Town of Camp Verde
Finnie Flat Channel Improvements

Town Of Camp Verde
Finnie Flat Channel Improvements
Cover Sheet

ALL REVISIONS DENOTED BY "CLOUD" SEALED BY Ronald Long

1 ~~Channel Access Ramp~~ Removed From Bid

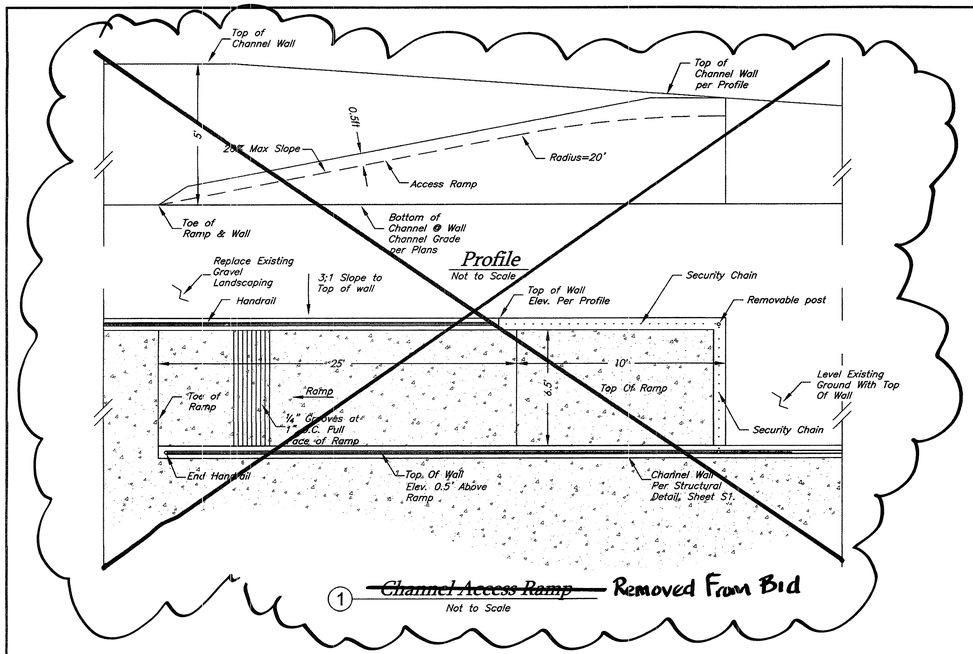
Revisions: Deleted Access Ramp Detail

15 Pedestrian Bridge

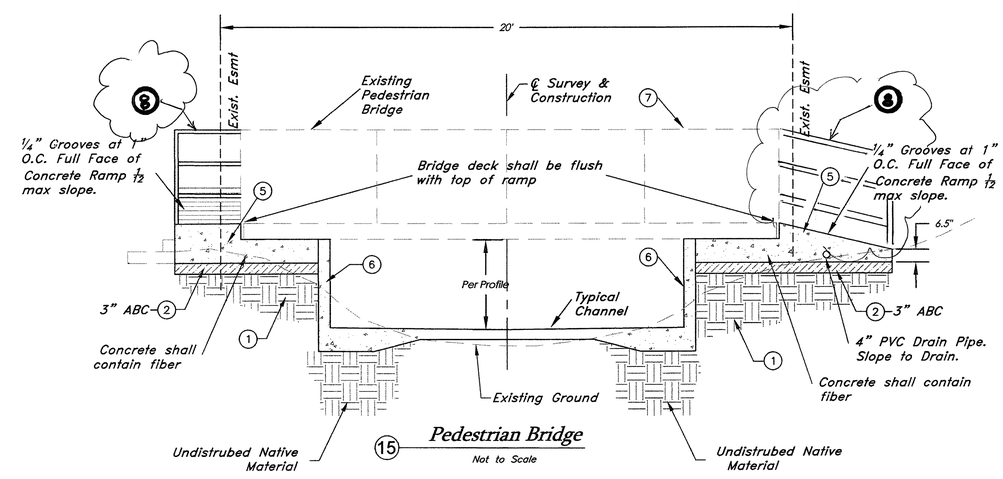
Revisions: Revised Detail #15 | Date: 1/17/12 | By: E

Section C-C

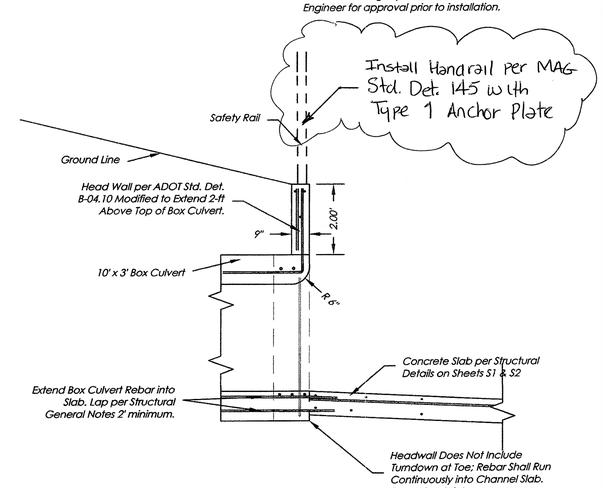
Revisions:	Date:	By:
Add Note to Section C-C	1/17/12	R

Dowel Note:
Drill 1" hole 3" Deep for 20M dowel in hole with an approved epoxy adhesive. Epoxy anchorage shall develop a tensile pullout strength of 13.7 kip-ft. Details of the anchorage system shall be submitted to the Engineer for approval prior to installation.

Town Of Camp Verde
Finnie Flat Channel Improvements
~~Add Alt~~ Rectagular Concrete Channel
Sta. 100+00 to 103+00

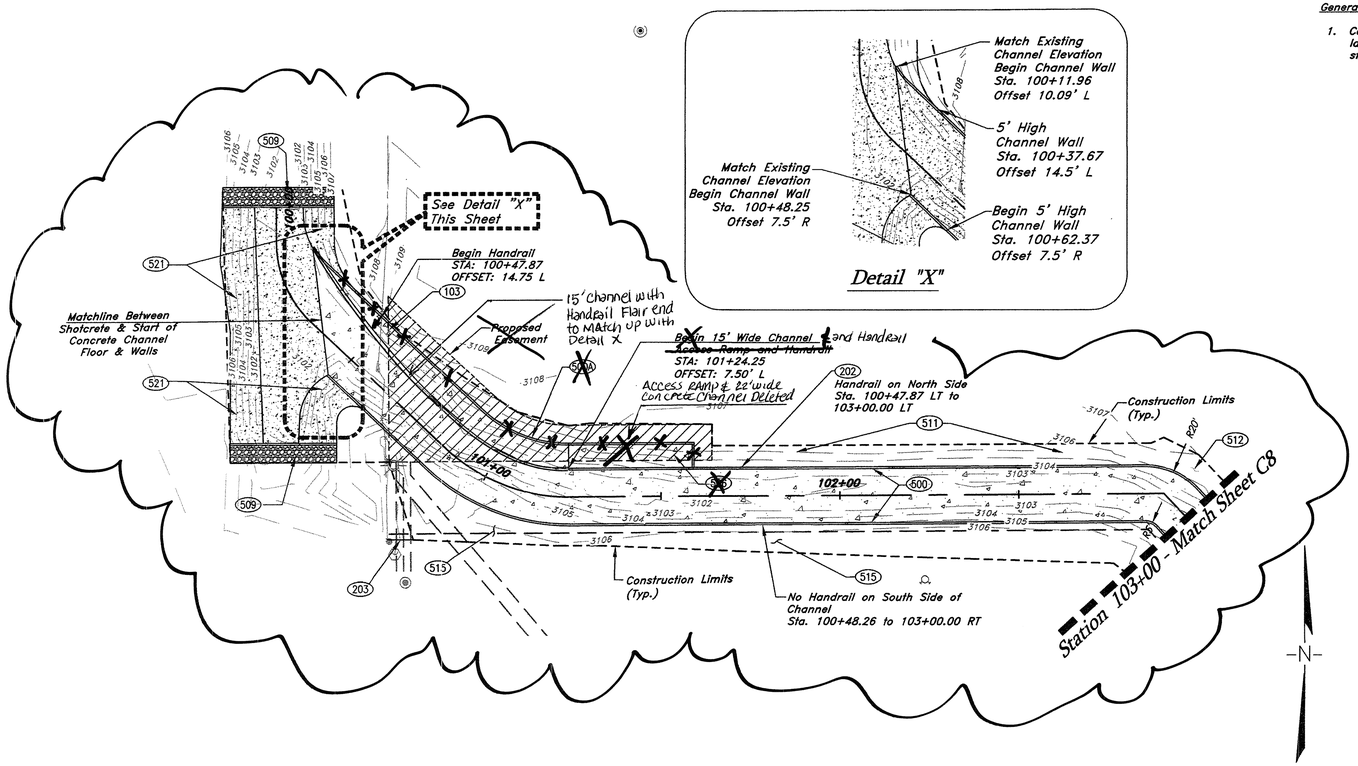
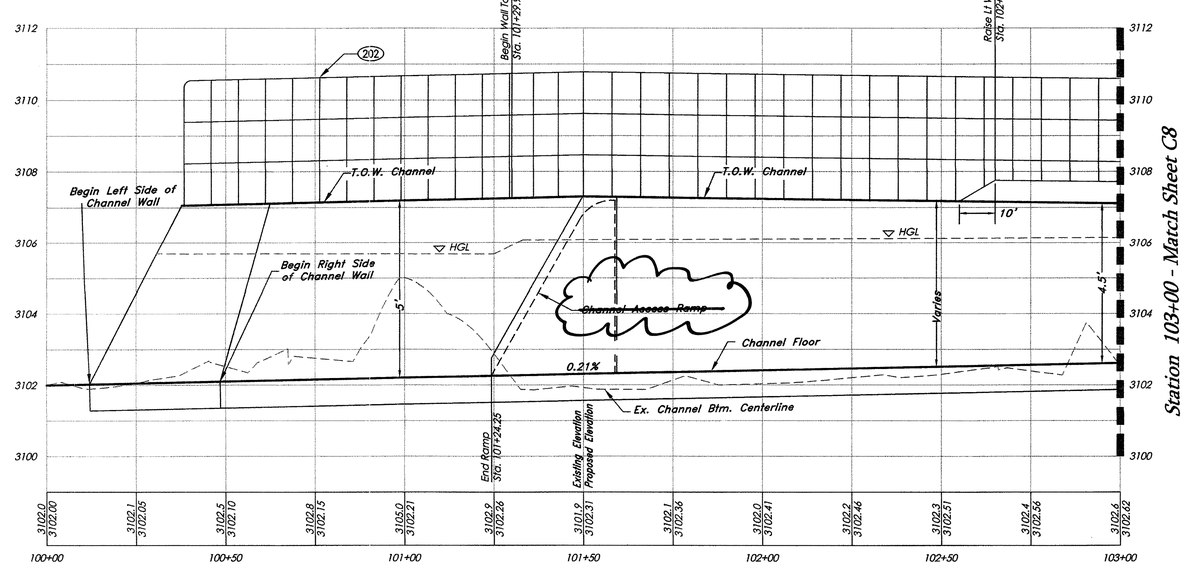
~~Note 500A 90 LF~~
~~Construct 22' wide Concrete Channel per Details 2 & 3, Sheet C3 and Structural Details on Sheets S1 & S2.~~

~~Note 506 1 LS~~
~~Construct channel access ramp per Detail 1, Sheet C3.~~

Revisions:	Date:	By:
Deleted Access Ramp and 22' Wide Channel.		
Revised Title and Construction Notes	1/17/12

Town Of Camp Verde
Finnie Flat Channel Improvements
~~Rectagular Concrete Channel~~
~~Add Alt Sta. 103+00 to 104+50~~
Base Bid Sta. 104+50 to 106+00

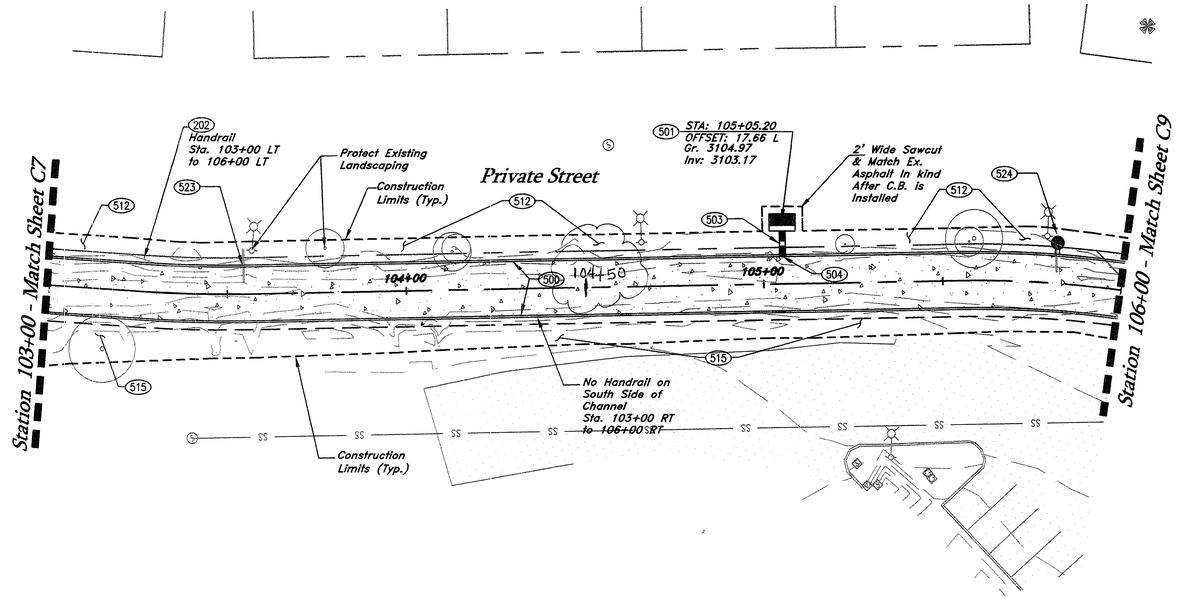
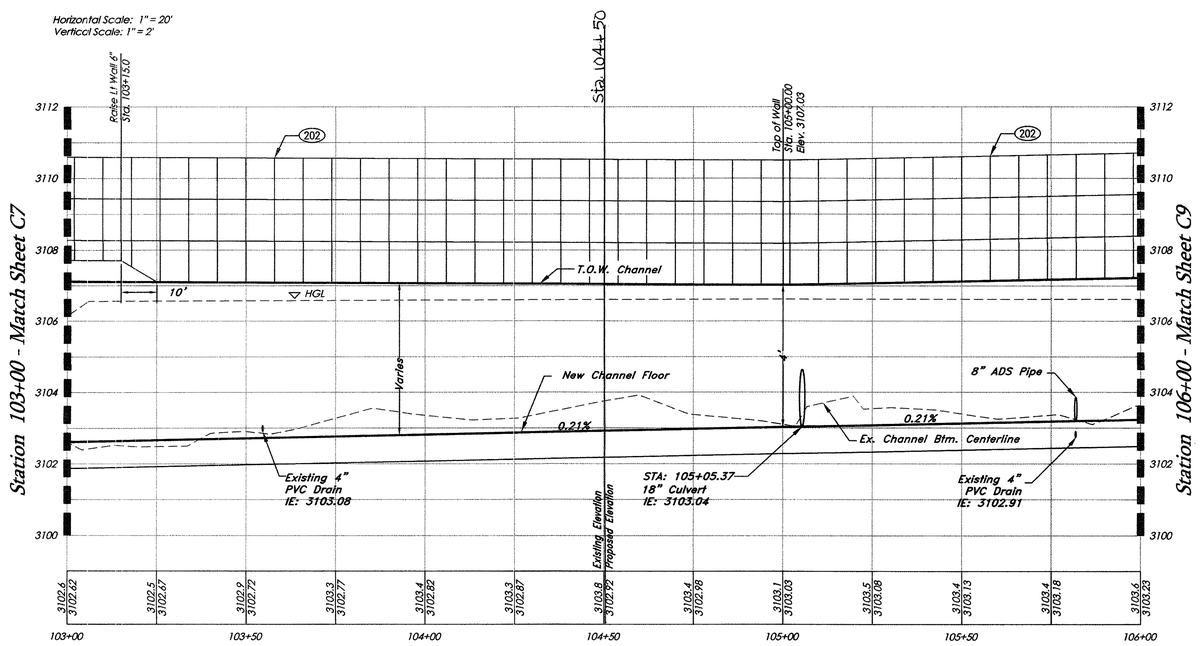
Revisions:	Date:	By:
Revised Sheet Title and added a general note.	7/7/12

Note: Options 1 and 2 start at Sta. 100+00 and end at sta. 104+50. The Base Bid Starts at sta. 104+50 and ends at sta. 113+70.18

Town Of Camp Verde
Finnie Flat Channel Improvements
Base Bid Rectangular Concrete Channel
Sta. 106+00 to 109+25

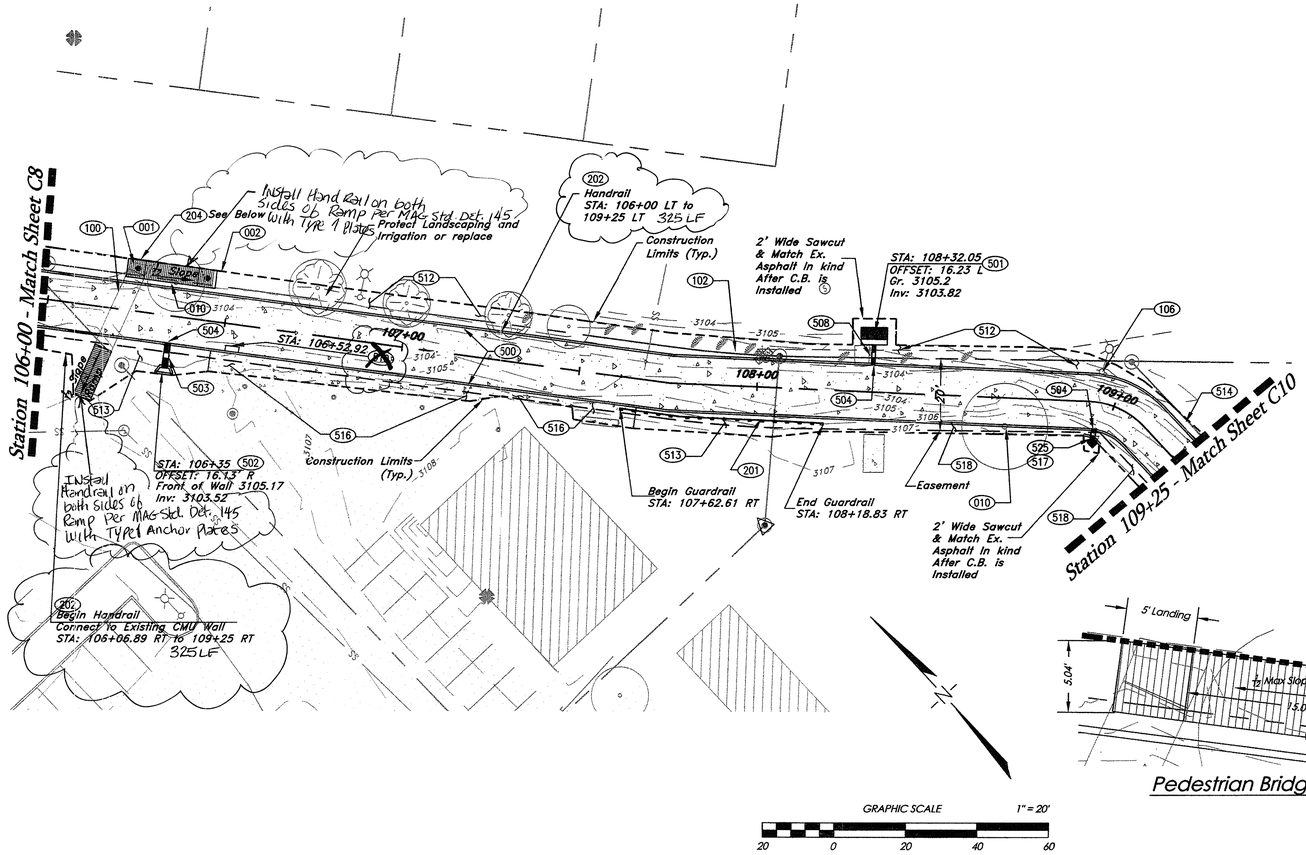
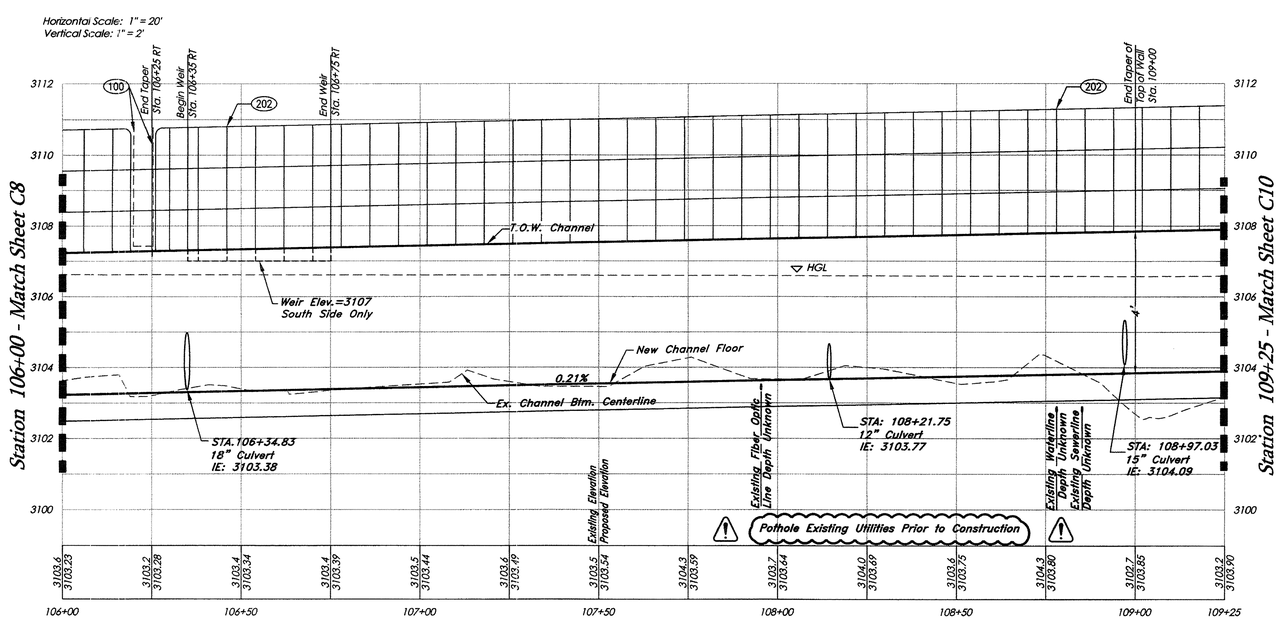
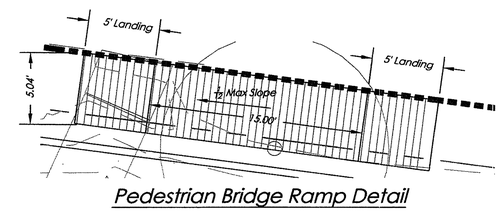
Note 202 ~~300~~ 650 LF
Install Handrail per MAG Std. Det. 145 with Type 1 Anchor Plate Detail. Terminate Handrail 3 inches on either side of the pedestrian bridge.

~~Note 510 1 EA~~
~~Install slope per MAG Std. Det. 428.~~

Revisions:	Date:	By:
Revised Quantity of Handrail - Note 202	—	—
Add Note for Handrail on both sides of both pedestrian ramps. Delete Note 510	1/17/12	R

Note 204 200 SF
Construct pedestrian bridge ramp max slope of 8.33% per Detail 15, Sheet C4 and Detail this sheet. Slope landings at 2% toward the street. Ramp construction includes handrail on both sides.
